UNECE R64 : RFT & RFWS

Tyre Industry position

Tyre Industry's concern over R64

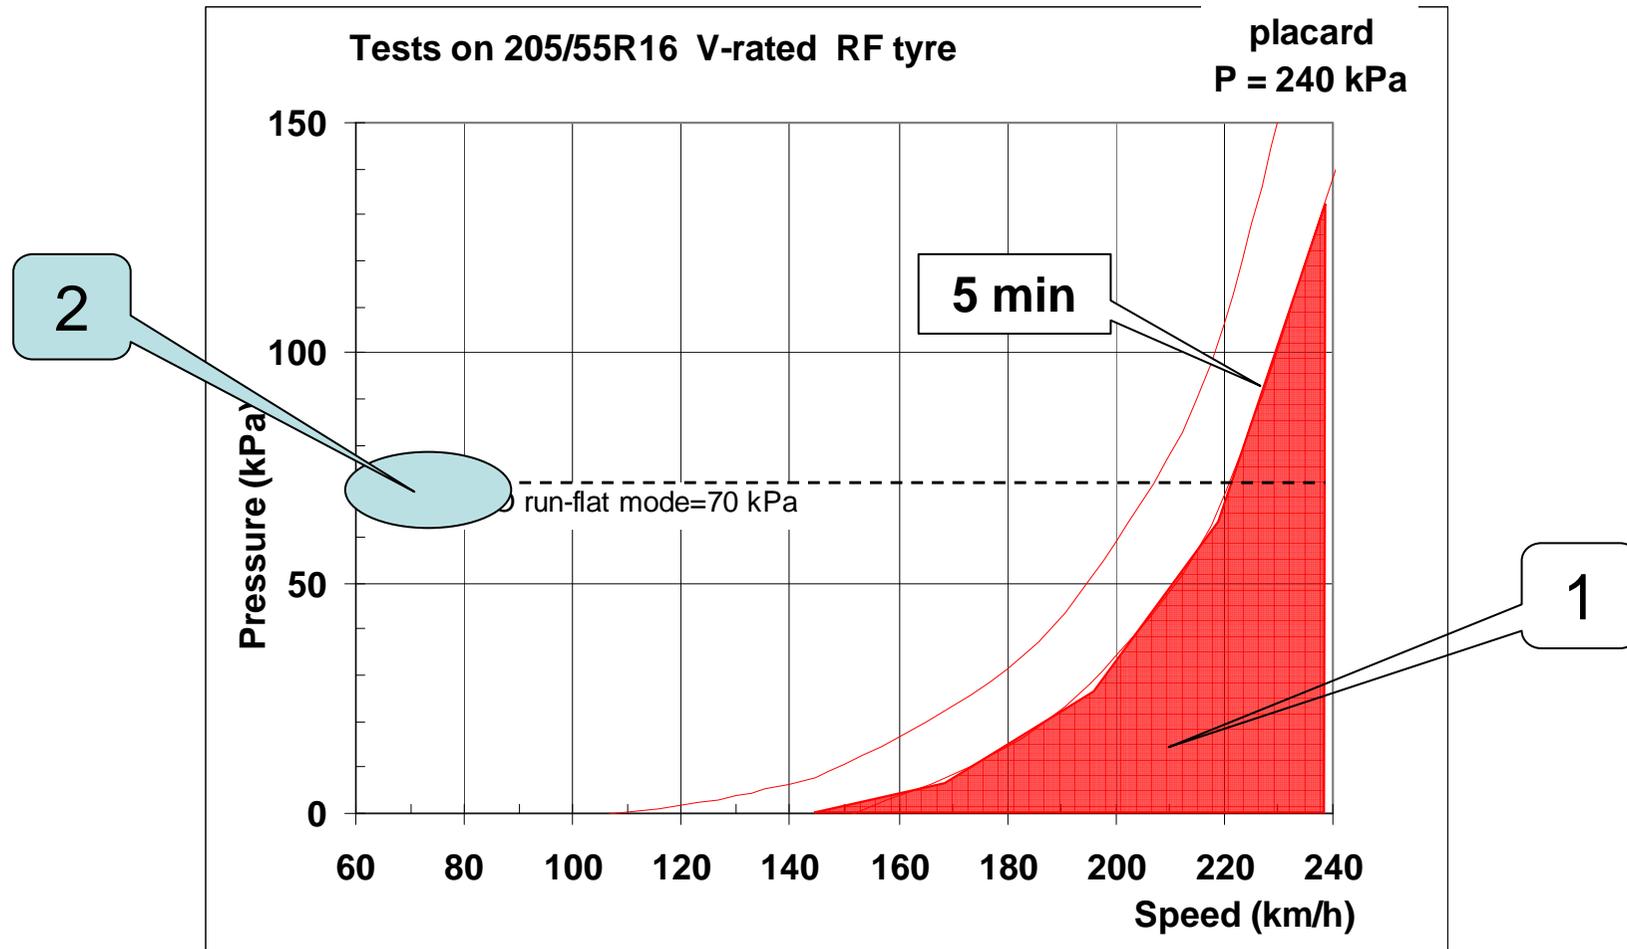
- To comply with Dir 2001/95 EC on general product safety, Tyre Makers insist on the following :
 - the RFWS must assure that the “low endurance zone” cannot be entered by a RFT
 - the homologation procedure of RFWS must be consistent with this need.

The RFWS must prevent the RF-tyre from entering zone 1

Present test method proposed to WP29 :

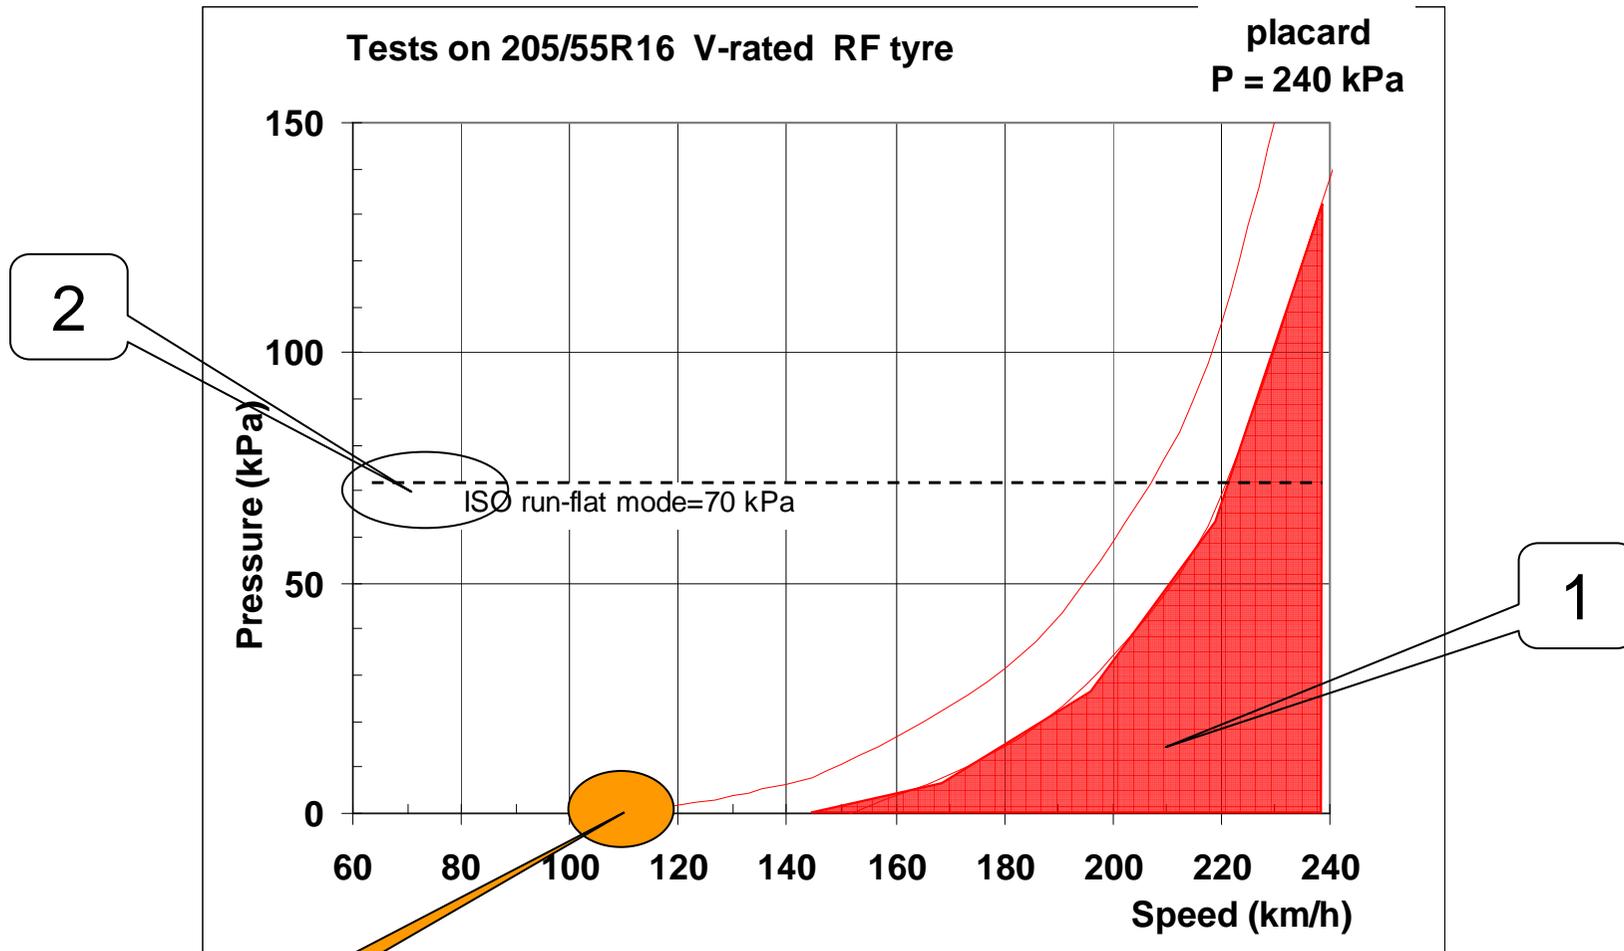
set tyre pressure at 70 kPa ; drive at around 70 km/h ; the RFWS has 20 min to respond ; malfunction diagnostic also in 20 min.

3 This method will allow homologation of “slow” RFWS.
Incidents corresponding to point 3 may not be prevented

Tyre Industry proposal to GRRF

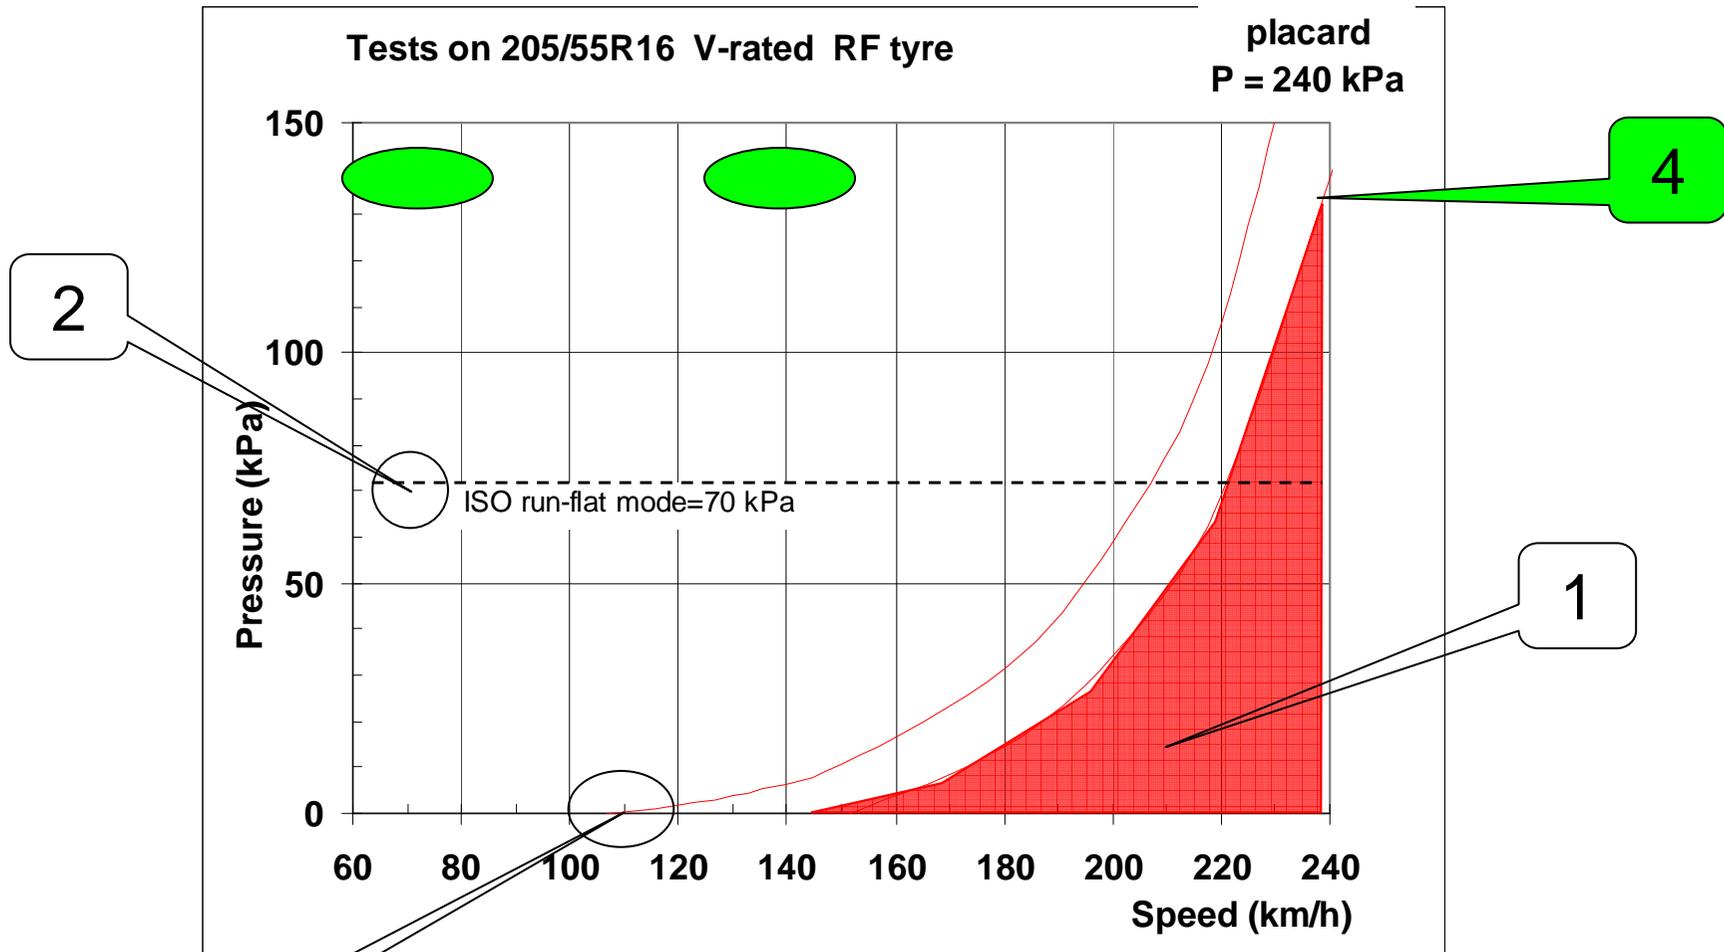
Tyre Industry proposed to GRRF to base the test method on ISO 21750

§ 5.1.6.5.1. Using a vehicle the tyres of which are correctly inflated at the recommended cold inflation pressure, produce on one tyre a **gradual pressure loss between 10 kPa/min and 20 kPa/min** and check while driving **at any speed above 25 km/h** that the system delivers an alert **at the latest for a pressure drop of 100 kPa.**

§ 5.1.6.6. The self-diagnostic function of the system shall be able to deliver information within **5 minutes** in driving conditions exceeding 25 km/h in case of malfunction
